# Pedestrian Safety Study

For South Atlantic Avenue (CR AIA)  
From New Smyrna Beach City Limits to 3rd Avenue

January, 2012

Prepared by:  
GMB Engineers & Planners, Inc.  
Orlando, FL

FIGURE 3: 8-HOUR PEDESTRIAN/BIKE VOLUMES

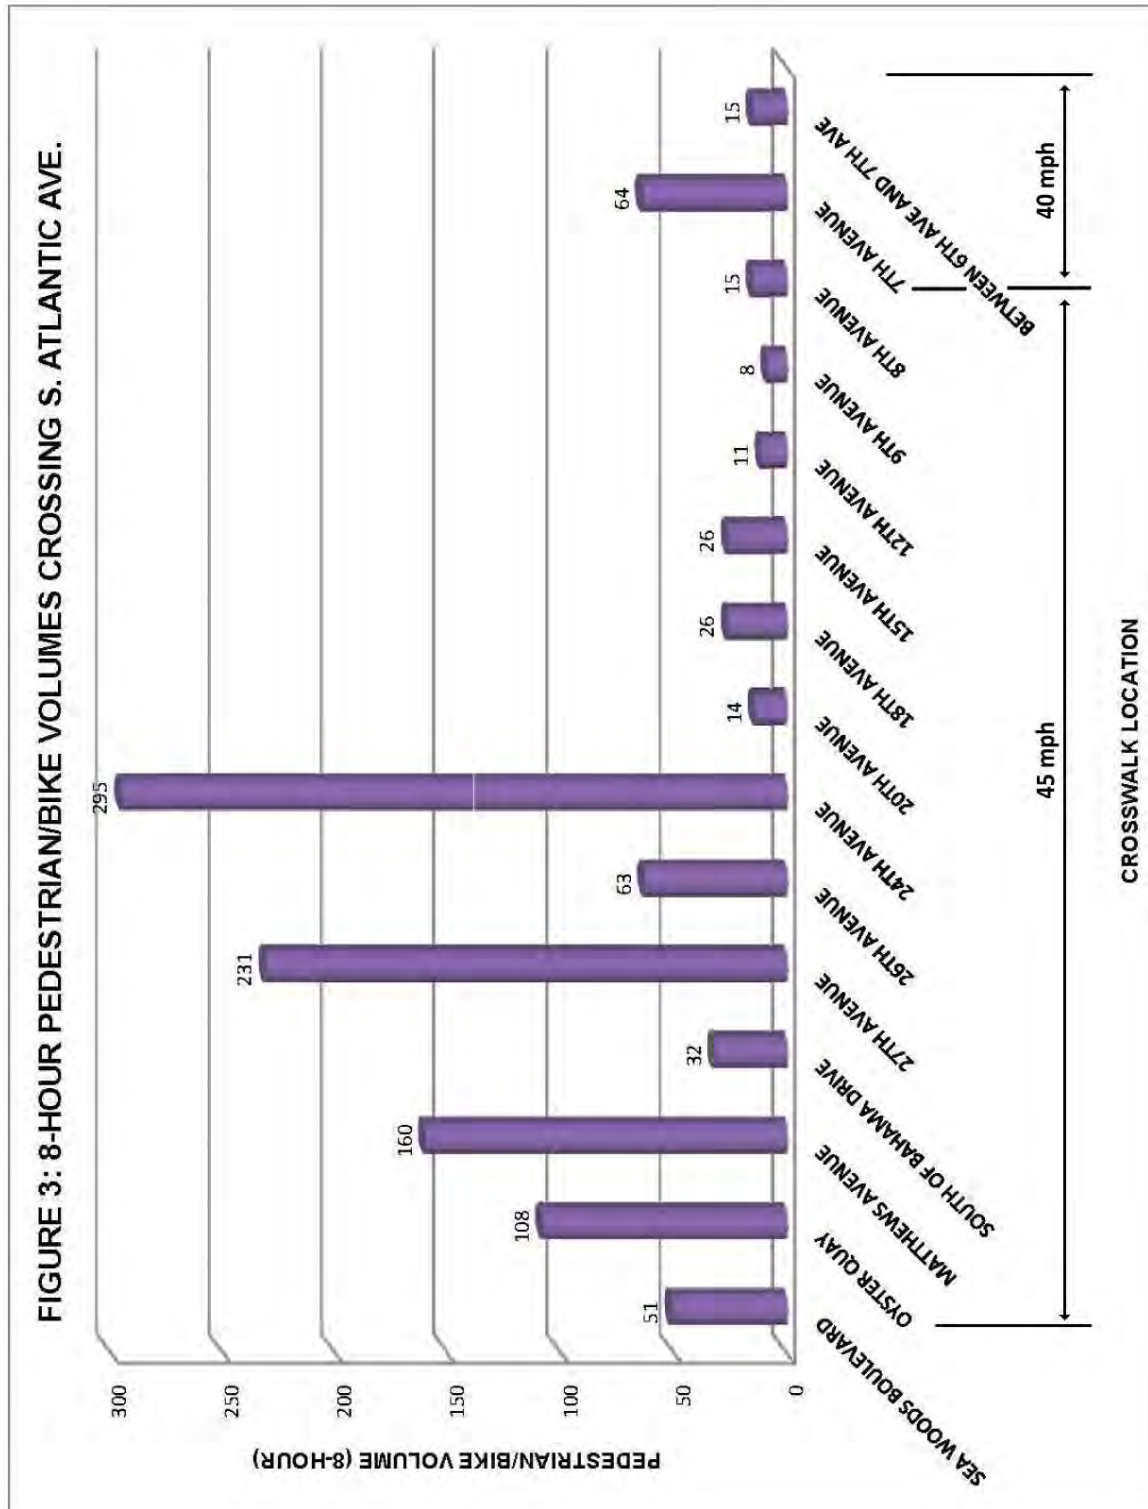
No.	Analysis Comments
1	Introduction, page 3: Please explain what prompted the study. Is it a City beautification project? Did residents complaints? Crashes?
2	Figure 3, page 21: It would be helpful to the reader if the study stated why the spike in pedestrian & bicycle activity is currently occurring in select locations (Oyster Quay, Matthews Avenue, 27th Ave, and 24th Ave). Is there a particular draw? Off-beach parking, shopping, restaurants on the west side?
3	Existing Conditions, page 4: The third paragraph contains errors with tense agreement.
4	Pedestrian and Bicycle Analysis, page 19: While Labor Day weekend usually has a high volume of traffic on the beach, it is also after the school year has started and may have a lower traffic volume then would occur during the peak summer season.
5	Page 24, 1st paragraph (last sentence): Please explain what is meant by "No Improper Driving."
6	LOS and AADT, page 42: Volusia County 2010 traffic counts are available.

FIGURE 4: 4-HR PEDESTRIAN/BIKE VOLUMES CROSSING S. ATLANTIC AVE.

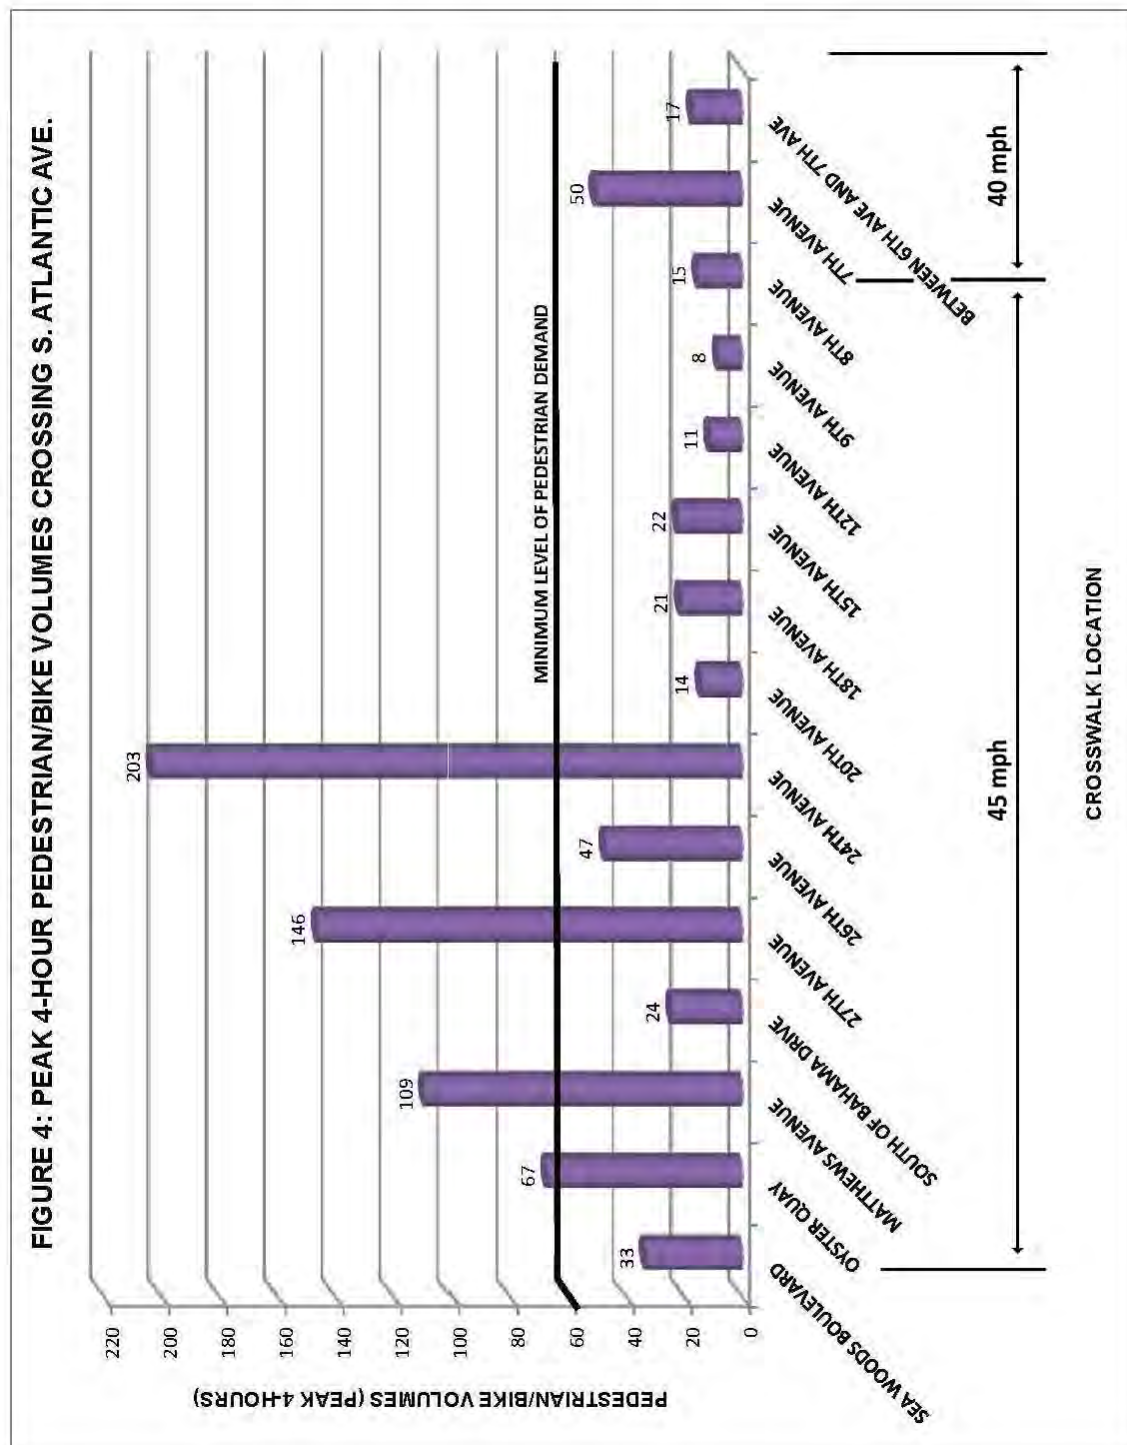
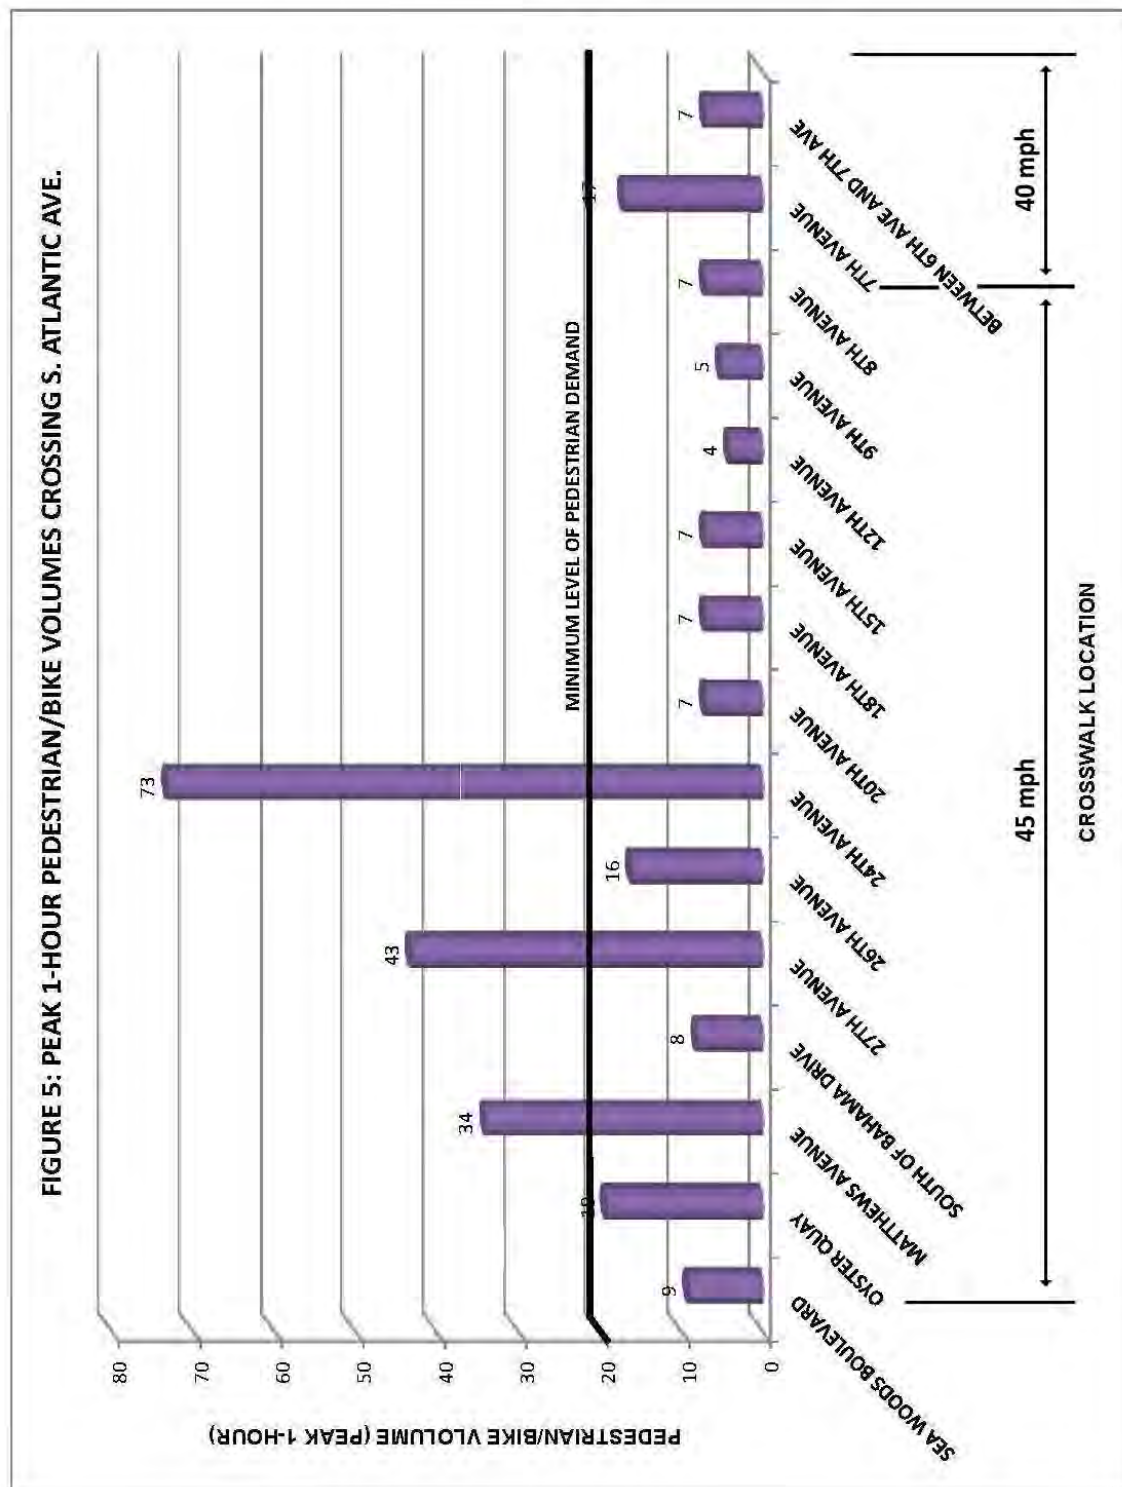
9. Pg 22, Figure 4 and pg 23, Figure 5 – please include a note explaining that the bold, horizontal line across the graph represents FDOT’s minimum pedestrian demand (count) threshold for mid-block crossings only. Also note that demand should be based on three consecutive days of data collection and include pedestrian volumes observed crossing the roadway outside a crosswalk at or in the vicinity of the proposed location, or at an adjacent (nearby) intersection. (FDOT’s Traffic Engineering Manual, Section 3.8, January 2010).
